FIRE SAFETY INSPECTION REPORT

**TANAZ FASHION, LTD.
SHATAIS ROAD**

ACCORD
on Fire and Building Safety in Bangladesh

March 15, 2014

F-7 Egress

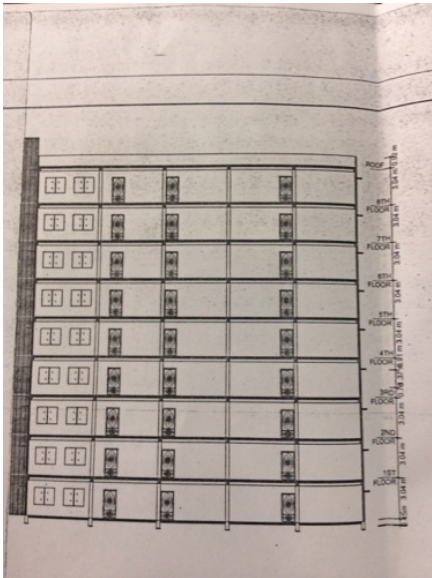
Storage was located in the exit stair.

Both stairs.

Remove all storage from exit stairs and egress paths.
